HEFLIN POLICE STATION
850 Ross Street
Heflin, Alabama

ADDENDUM NUMBER THREE

January 9, 2026

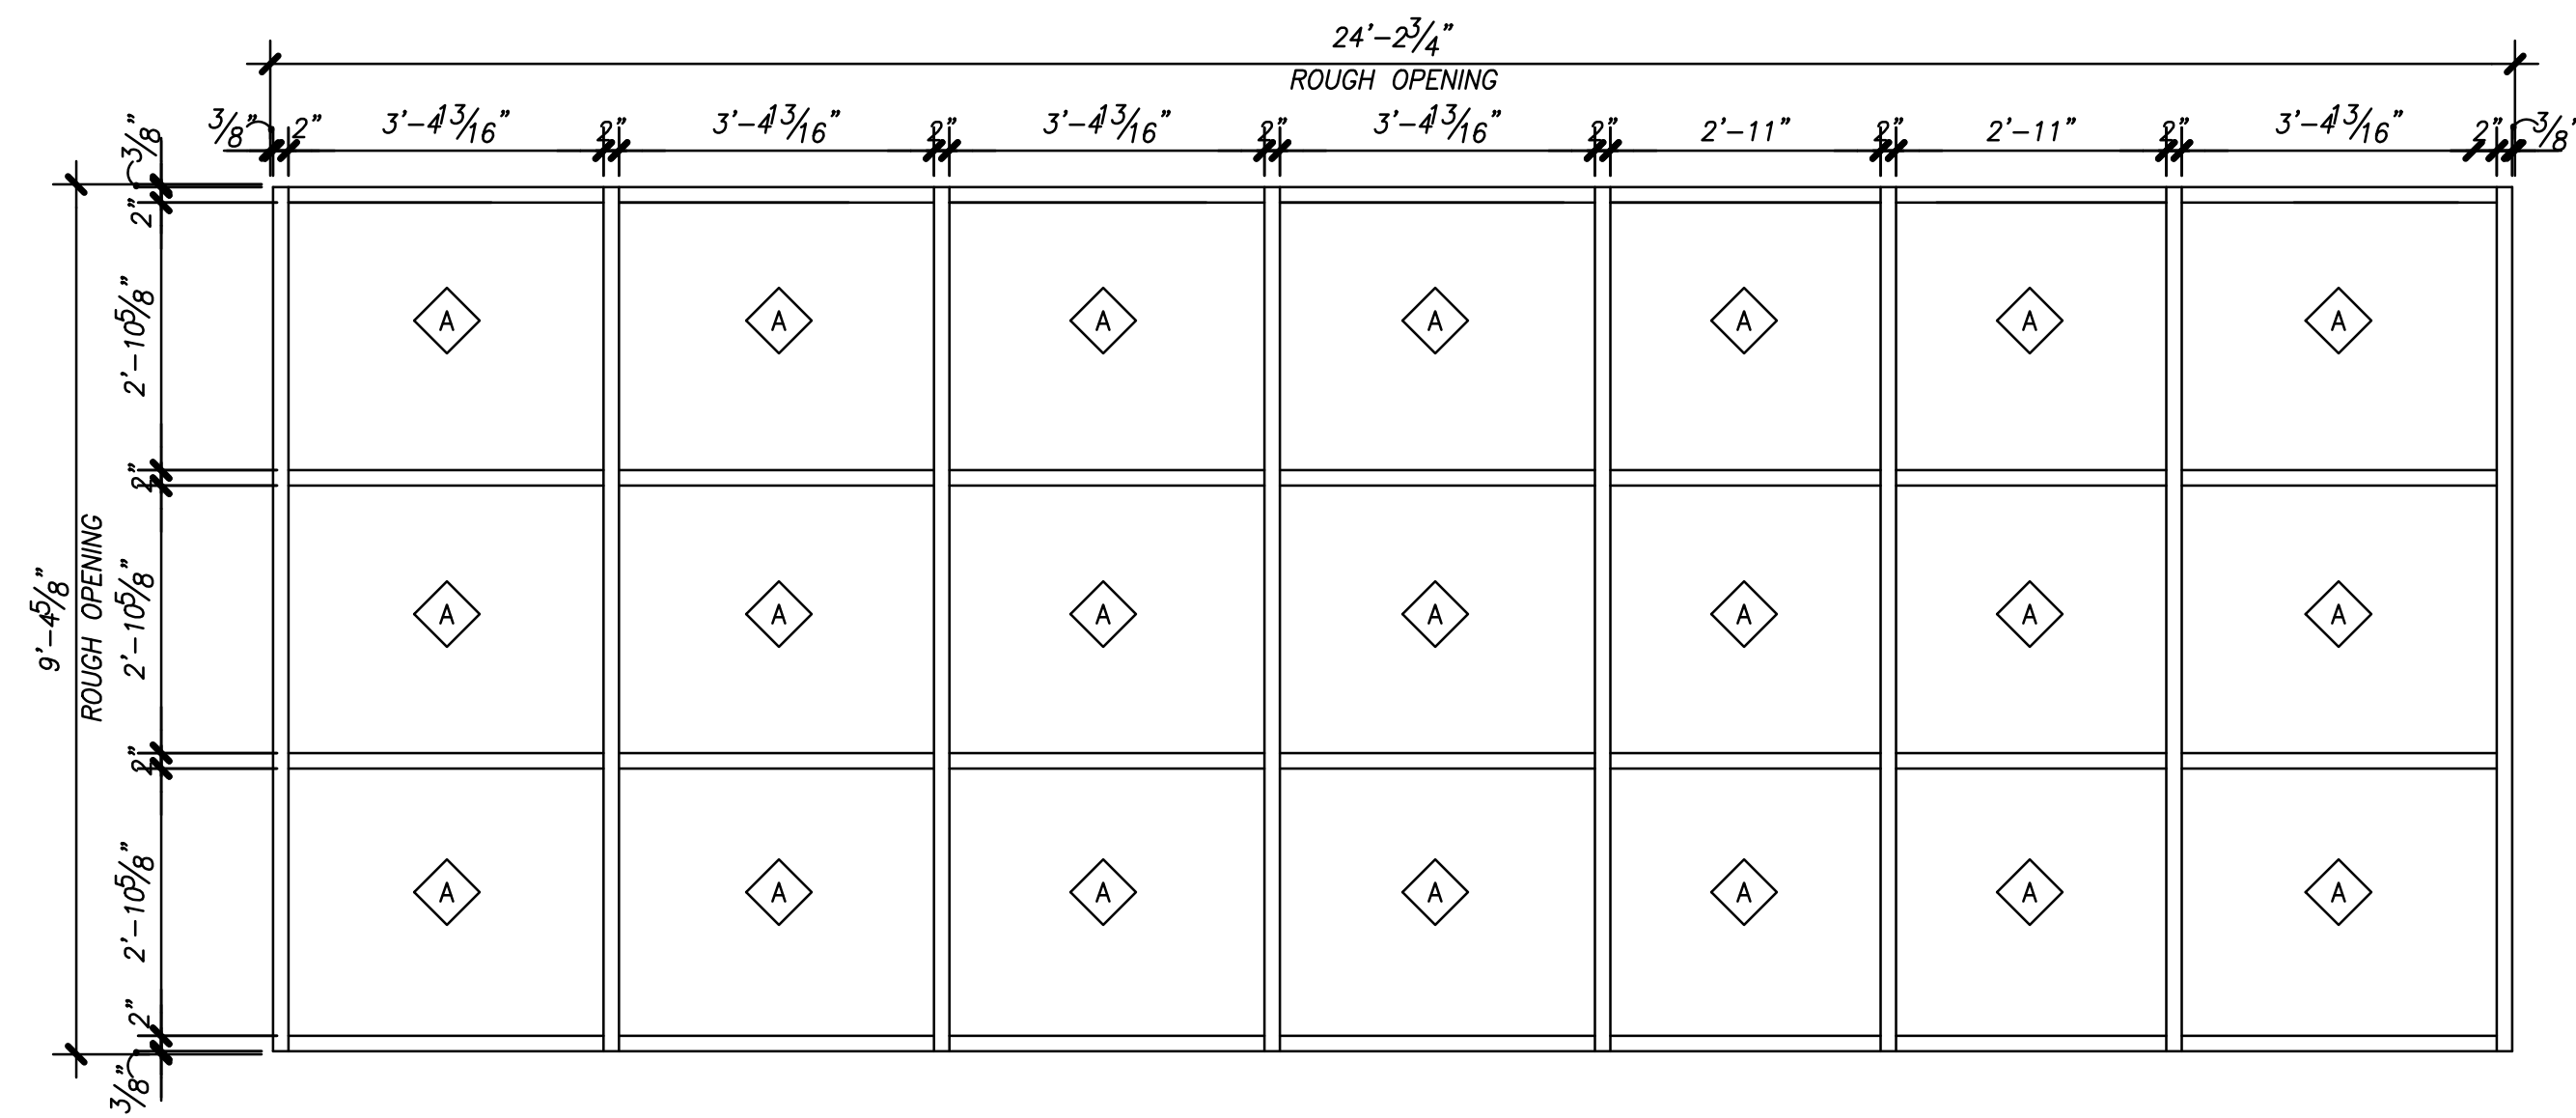
1. Omit all references to the Davis Bacon Act from the Documents. Davis Bacon is not applicable to this Project.
2. At the first line of Section 00300 of the Specifications, PROPOSAL FORM, change "Honorable Robbie Brown, Mayor, City of Hoover" to "Honorable Robbie Brown, Mayor, City of Heflin".
3. At 07210.3.5 of the Specifications, add:

J. Install R-13 glass-fiber batt insulation continuous at the underside of the new roof deck.
4. At 07220.2.1.B.1 of the Specifications, change "RSI-57 (R-33), minimum" to "R-26, minimum".
